563- 573 Riverside street, Portland, ME

Amendment to Plan - six G's coed LL

**SUBJECT:** Six G's Coed, 567 Riverside Street  
Site Plan Review

**Site Plan Application, Six G's Coed, LLC.,**  
**6000 S.F. Office/Warehouse Building, 563 Riverside Street**  
**ID # 2005-0165, CBL #306-B-001**

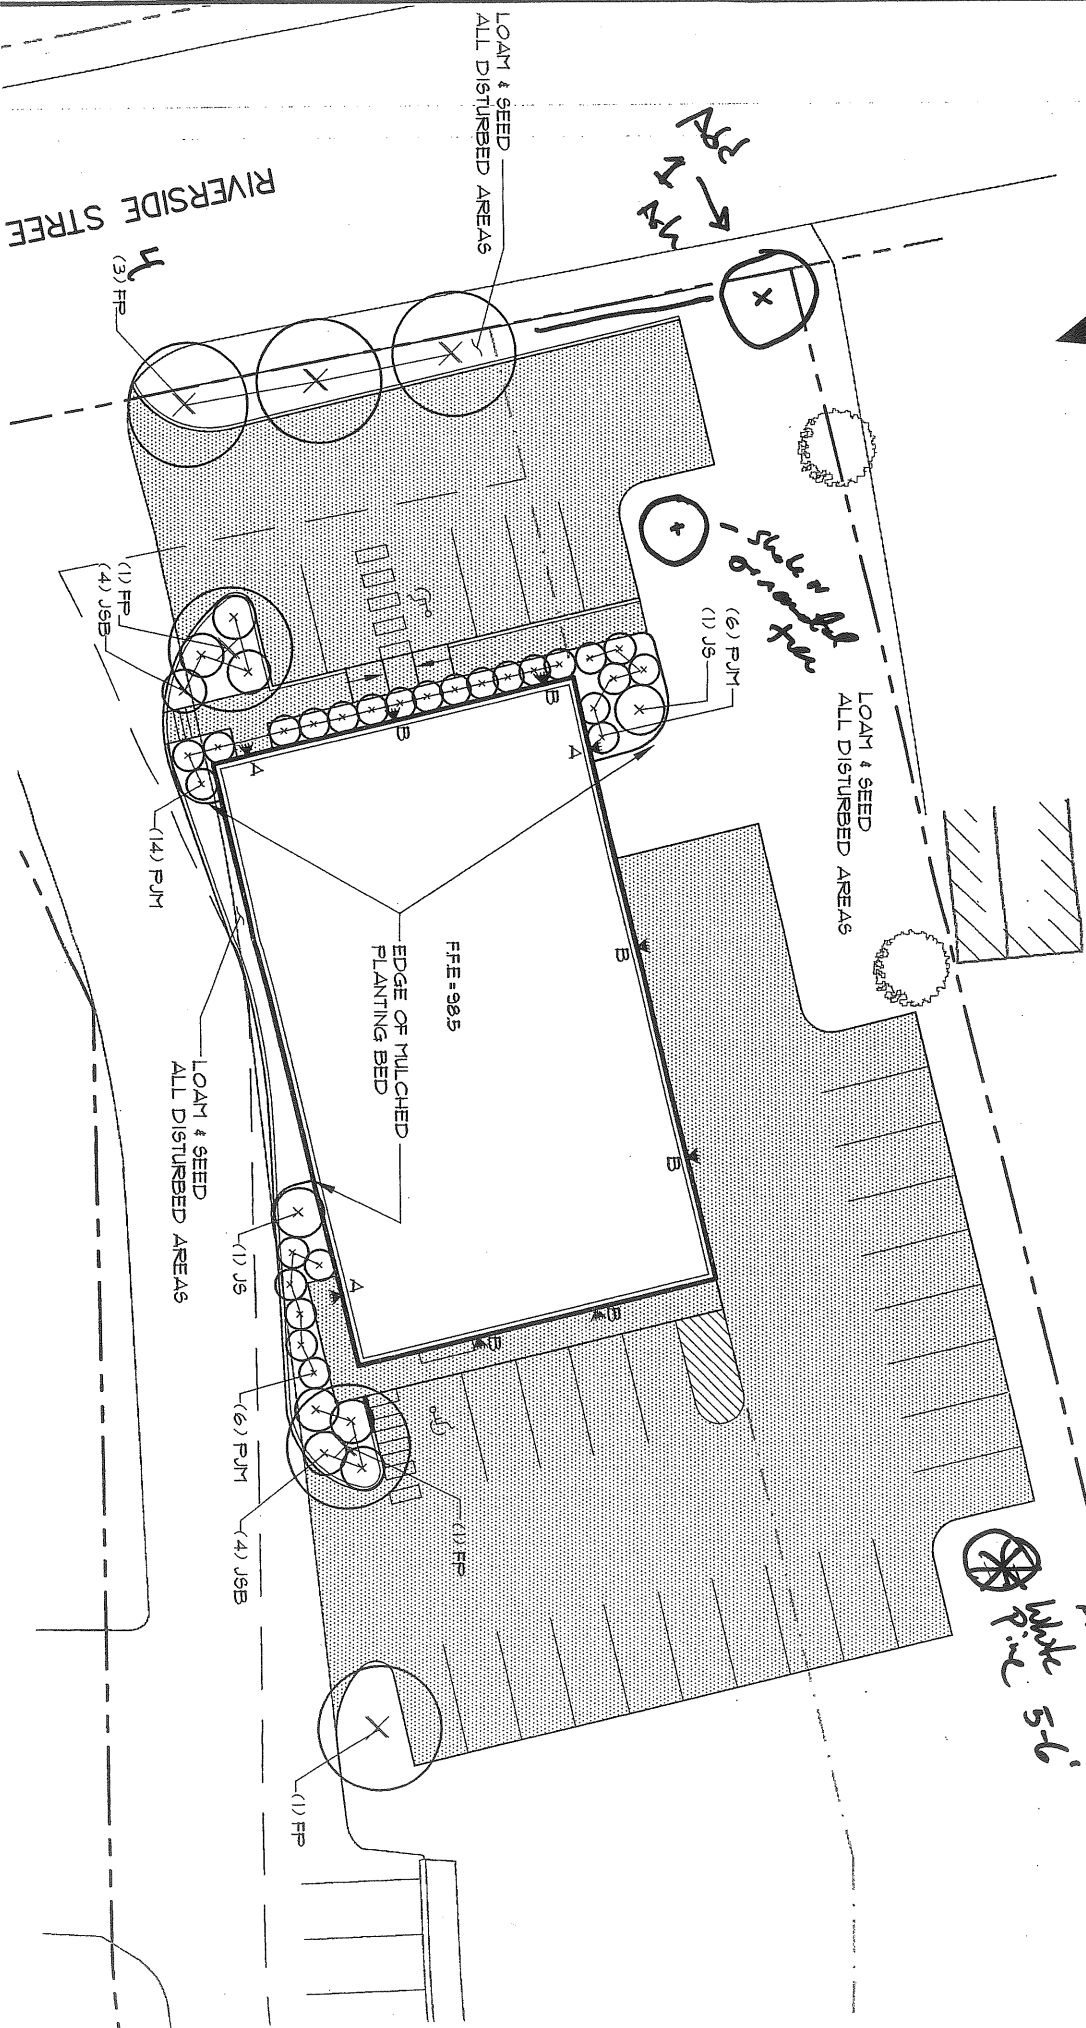
7. The City Arborist is currently reviewing the landscaping plan. Additional comments from the City Arborist shall be forwarded to you.
  8. Is there sidewalk and granite curb along the frontage of the site? If not, Chapter 25 requires that sidewalk and granite curb be installed. The plans must be revised to show sidewalk and granite curb. Was a waiver granted as part of the previous approval. A waiver of sidewalk and granite curb may be requested, but must meet the sidewalk and granite curb waiver requirements. The sidewalk waiver criteria are attached for your review.

7. Responses to comments will be provided as they are received from the City Arborist. In accordance with our discussions with Jay Reynolds, additional trees are proposed on the enclosed Landscaping Plan to allow for a release of this Performance Guarantee for the original site.

Handwritten arrows and notes pointing to specific plantings.
